Access Compliance Report

Public Rights-of-Way

(Curb Ramps)

Intersection ID: 10027594	Main Street: GREEN_RIDGE_DR	Cross Street: N/A	Location:	N
ADA ID: E660A623CEDF	Ramp Type: PerpDiag	Initial Pass/Fail: Fail	Overall Compliance: No	Severity Score: 12.5
Codes/Mitigation Info/Possible Solution		Field Measurements/Component Compliance

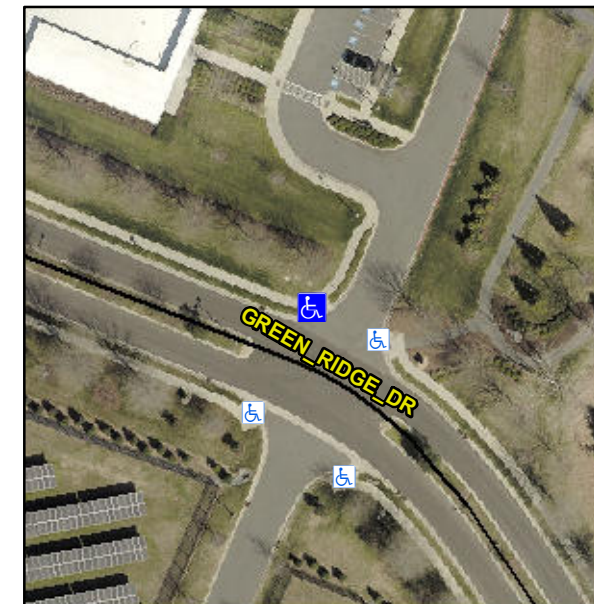
Not Found, R304.2.2

Compliance	Description	Data	Compliance	Description	Data
N/A	Ramp Length (in)	48.0	No	Ramp Slope (%)	10.0
Yes	Ramp Width (in)	48.0	Yes	Ramp XSlope (%)	0.6
N/A	Flare Type LT	N/A	N/A	Flare Type RT	N/A
N/A	Flare Slope LT (%)	N/A	N/A	Flare Slope RT (%)	N/A
N/A	Flare Traversable LT?	N/A	N/A	Flare Traversable RT?	N/A
N/A	Landing Length (in)	N/A	N/A	DWS Provided?	N/A
N/A	Landing Width (in)	N/A	N/A	DWS Contrast?	N/A
N/A	Landing Slope (%)	N/A	N/A	DWS Length (in)	N/A
N/A	Landing X Slope (%)	N/A	N/A	DWS Full Width?	N/A
N/A	Landing Curb? (Y/N)	N/A	N/A	DWS Offset (in)	N/A
N/A	Shared Landing?	N/A			
N/A	Gutter Ponding?	N/A	N/A	Gutter Slope (%)	N/A
N/A	Gutter Lip Ht (in)	N/A	N/A	Gutter X Slope (%)	N/A
N/A	Painted X Walk1?	No	N/A	Painted X Walk2?	No
	X Walk 1 Direction	To SW		X Walk 2 Direction	To SE
N/A	X Walk 1 Width (in)	N/A	N/A	X Walk 2 Width (in)	N/A
	X Walk 1 Slope (%)	1.3		X Walk 2 Slope (%)	2.3
	X Walk 1 X Slope (%)	1.8		X Walk 2 X Slope (%)	0.7

Remove & Replace Curb Ramp With Two New Directional Ramps or Equivalent.
